## LAKE NONA PARCEL 15A

<p><b>Owner</b> Rasesh Thakkar Landport Land Holdings, LLC</p> <p><b>Applicant</b> Heather Isaacs Tavistock Development Co.</p> <p><b>Project Planner</b> Colandra Jones, AICP</p>	<p><b>Property Location:</b> The subject property is located west of Lake Nona Boulevard, north of Central Florida Greenway (SR 417), south of Lake Nona Gateway Road (±26.9 acres, District 1).</p> <p><b>Applicant's Request:</b> Specific Parcel Master Plan (SPMP) approval and Major Subdivision Plat to create the Preliminary Plat for a three story 66,000 square foot sports and entertainment facility.</p> <p><b>Staff's Recommendation:</b> Approval subject to the conditions in the staff report.</p>	
<b>Updated:</b> October 10, 2016

CONCEPTUAL SIGNAGE

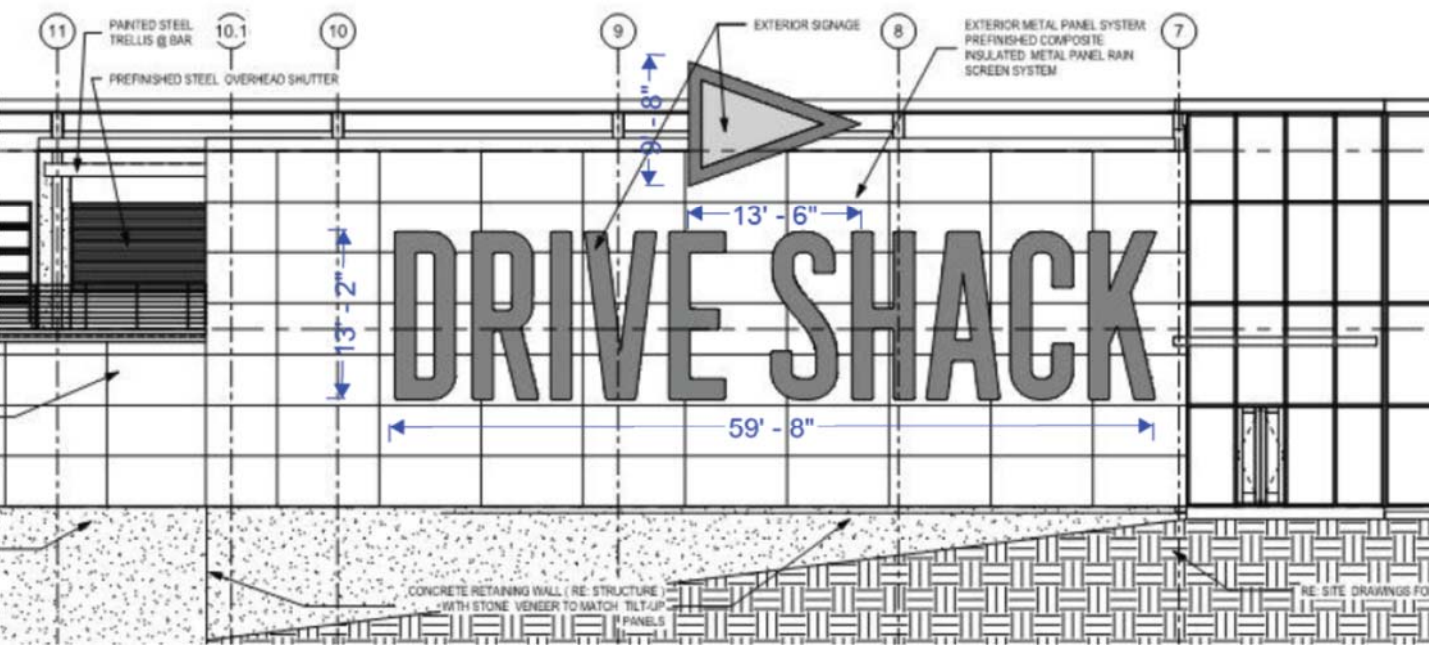
The proposed signage shall be consistent with Chapter 64 of the LDC. The roof sign in the conceptual drawing is prohibited. A complete signage package will be subject to Appearance Review prior to the issuance of building permits. Signage shall be two square feet per linear foot of building frontage facing the access road.

# LANDSCAPE PLAN

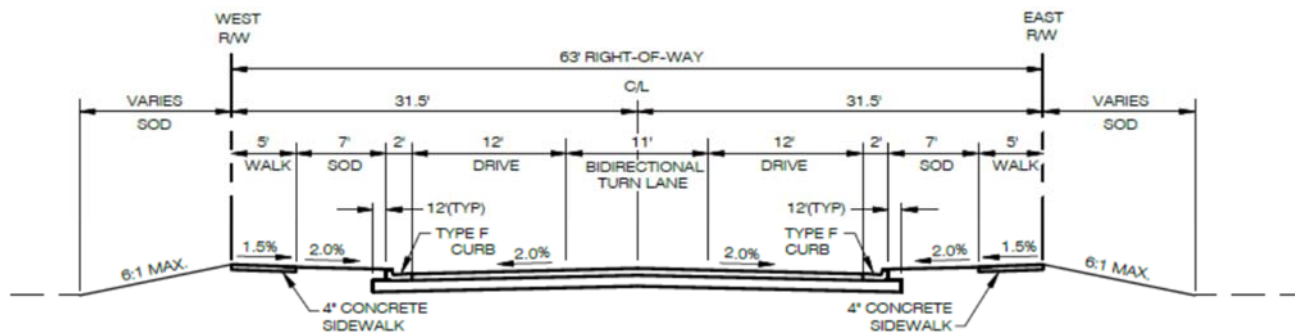
1. Complete sidewalks from access road to the internal site's walkways to the front of the building.
2. Some of the landscaping plans are inconsistent; meet city code requirements for parking lot landscaping and peripheral landscaping. These items will be reviewed in detail at the time of permitting.
3. A final Planning Official determination is required for the final outdoor lighting details for sports facilities. A pre-application meeting shall be held with the appearance review staff prior to applying.
4. Consider coordination with the FAA and GOAA, regarding the height and caution lighting of the "net poles" due to the close proximity of the site to the airport.
5. Orient any outdoor speakers to face towards the west (towards the airport), directed away from residential uses to the northeast and east.
